P0299 Ellenor Hospice

KEY - Amendments to current approved drawing 2201 Rev P6

Drawing
Proposed Sections

Project originator volume level type role number revision
P0299-RHP-ZZ-XX-DR-A- 2201 P6

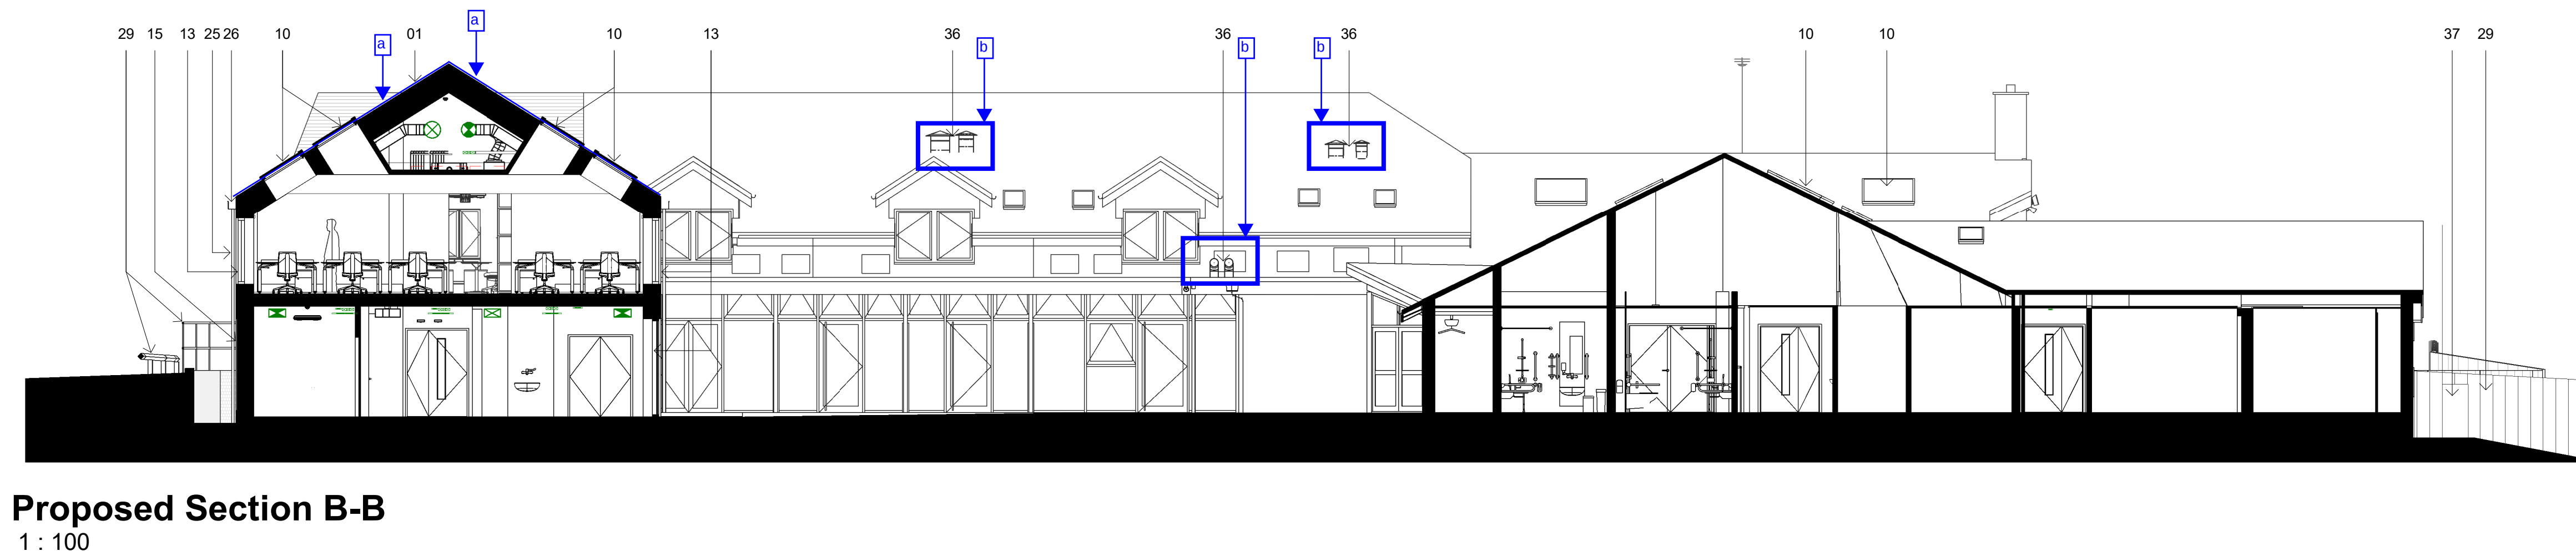
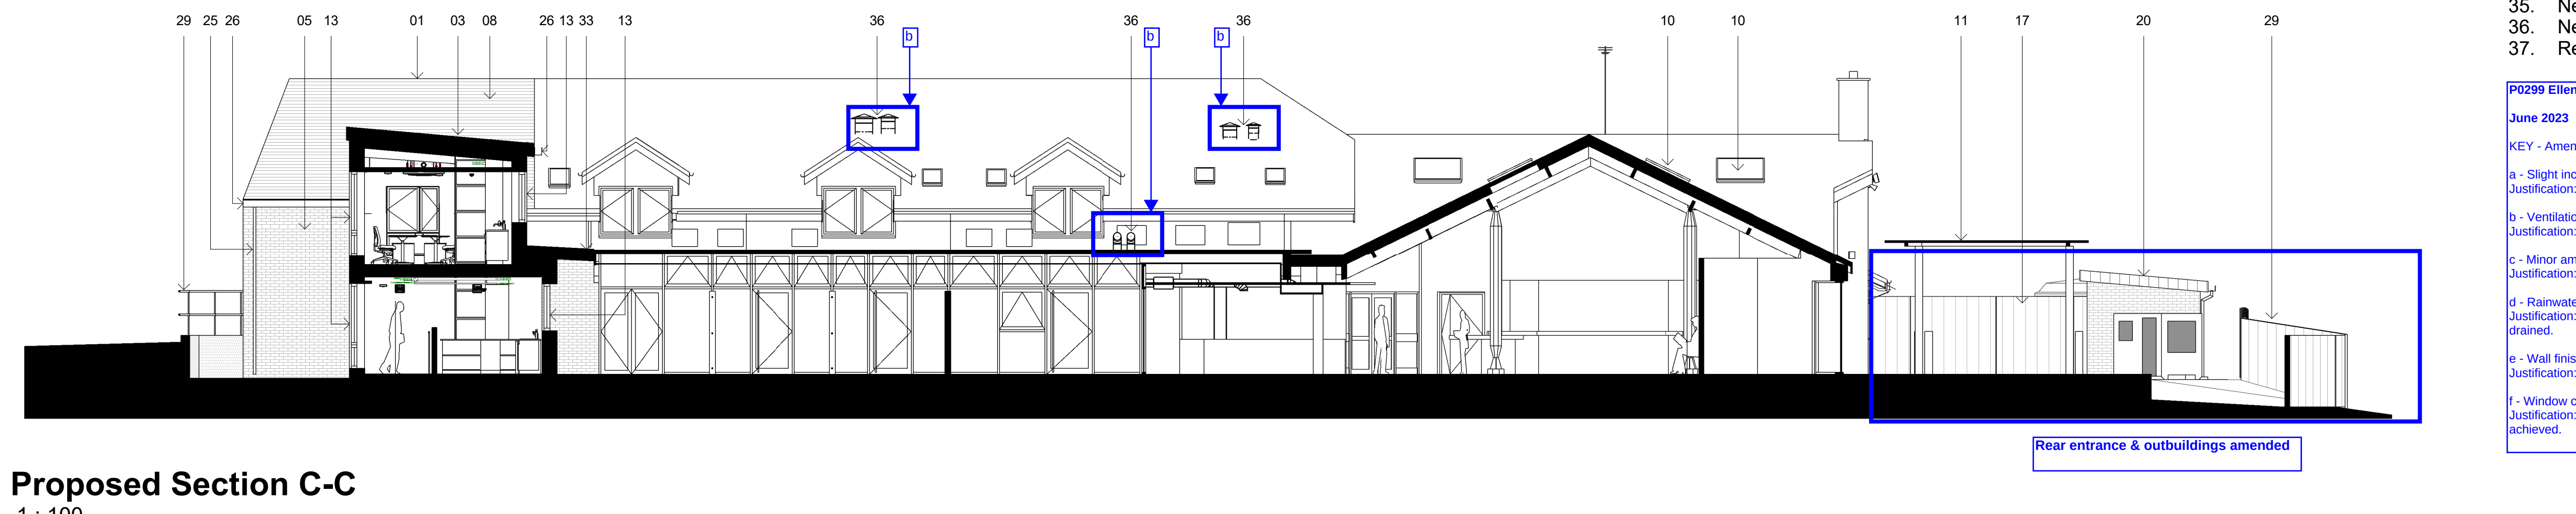
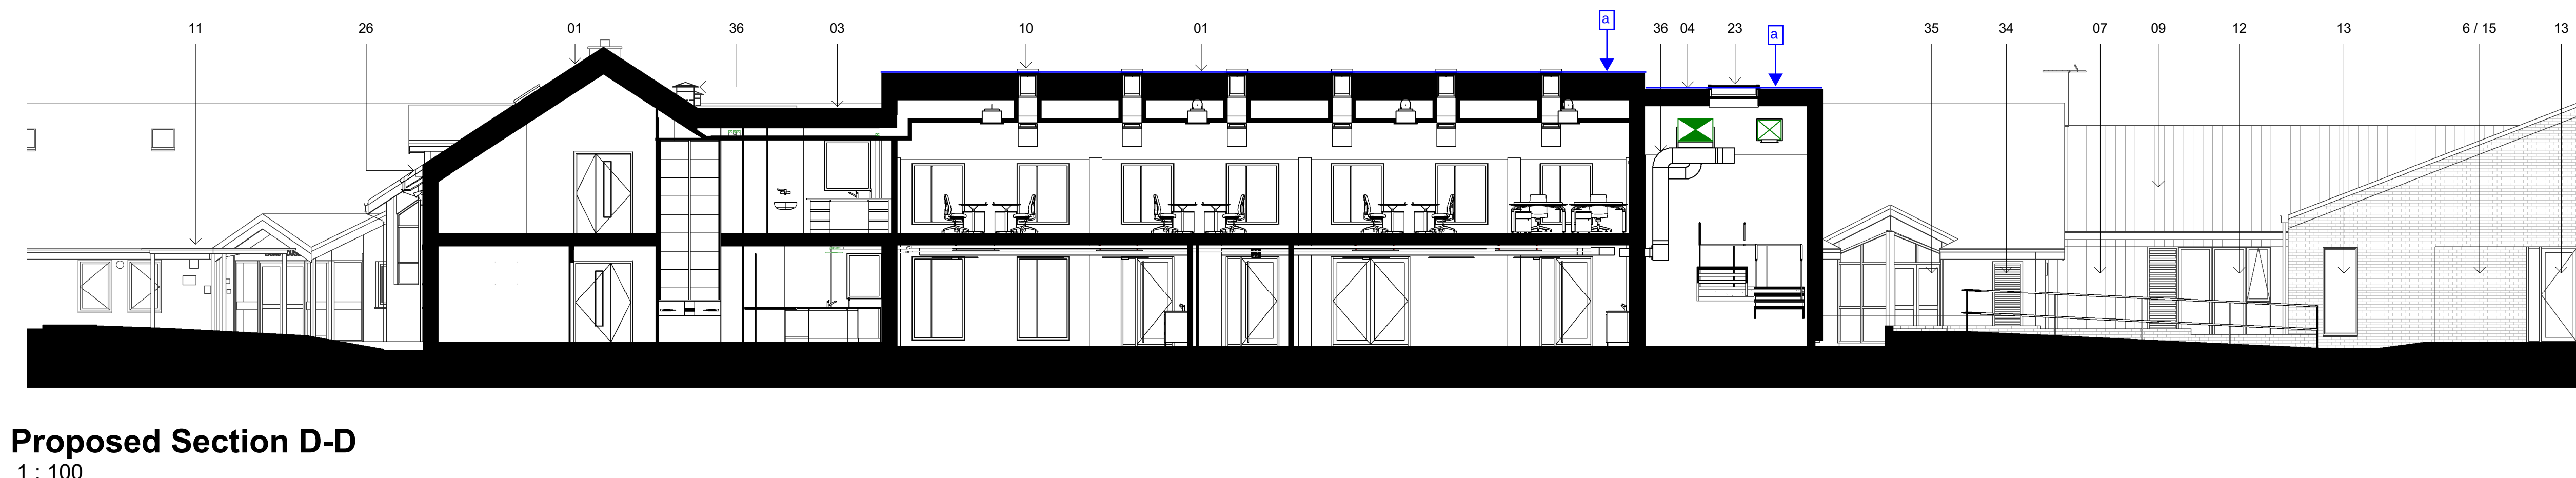
a - Slight increase in roof/ridge height
Justification: design development, to suit construction & fire protection detailing.

b - Ventilation ductwork omitted
Justification: mechanical ventilation no longer required.

c - Minor amendments to door/glazing arrangement
Justification: design development and/ or to achieve building control compliance

d - Rainwater pipe arrangement amended
Justification: design development- to ensure existing flat roof is adequately drained.

e - Wall finish changed to brickwork (was zinc cladding)
Justification: for buildability reasons.

f - Window cill height raised
Justification: for buildability reasons- to ensure a robust waterproofing detail is achieved.
